Access Compliance Report

Public Rights-of-Way

(Curb Ramps)

Intersection ID: 10023914	Main Street: CONFERENCE_DR	Cross Street: N/A	Location: NE
ADA ID: 53A06477B724	Ramp Type: Perp	Initial Pass/Fail: Fail	Overall Compliance: No
		Severity Score: 12.5

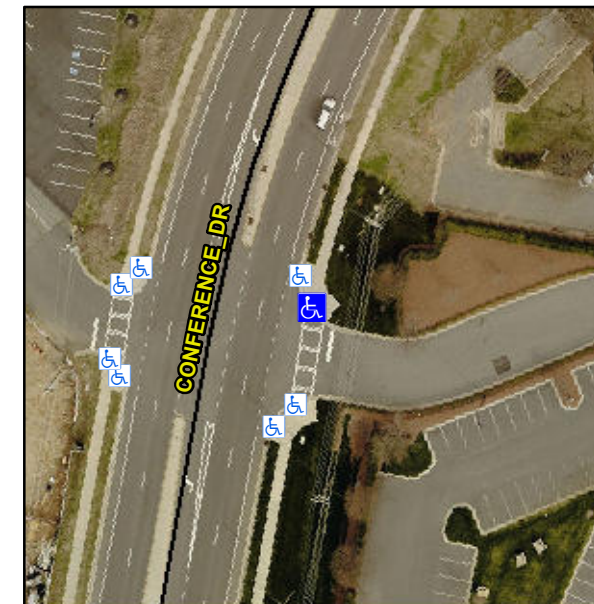
R304.2.2

Compliance	Description	Data	Compliance	Description	Data
N/A	Ramp Length (in)	67.0	No	Ramp Slope (%)	8.5
Yes	Ramp Width (in)	48.0	Yes	Ramp XSlope (%)	1.2
N/A	Flare Type LT	N/A	N/A	Flare Type RT	N/A
N/A	Flare Slope LT (%)	N/A	N/A	Flare Slope RT (%)	N/A
N/A	Flare Traversable LT?	N/A	N/A	Flare Traversable RT?	N/A
N/A	Landing Length (in)	N/A	N/A	DWS Provided?	N/A
N/A	Landing Width (in)	N/A	N/A	DWS Contrast?	N/A
N/A	Landing Slope (%)	N/A	N/A	DWS Length (in)	N/A
N/A	Landing X Slope (%)	N/A	N/A	DWS Full Width?	N/A
N/A	Landing Curb? (Y/N)	N/A	N/A	DWS Offset (in)	N/A
N/A	Shared Landing?	N/A			
N/A	Gutter Ponding?	N/A	N/A	Gutter Slope (%)	N/A
N/A	Gutter Lip Ht (in)	N/A	N/A	Gutter X Slope (%)	N/A
N/A	Painted X Walk1?	Yes	N/A	Painted X Walk2?	N/A
	X Walk 1 Direction	To S		X Walk 2 Direction	N/A
N/A	X Walk 1 Width (in)	112.0	N/A	X Walk 2 Width (in)	N/A
	X Walk 1 Slope (%)	0.2		X Walk 2 Slope (%)	N/A
	X Walk 1 X Slope (%)	1.4		X Walk 2 X Slope (%)	N/A

Remove & Replace Entire Ramp.
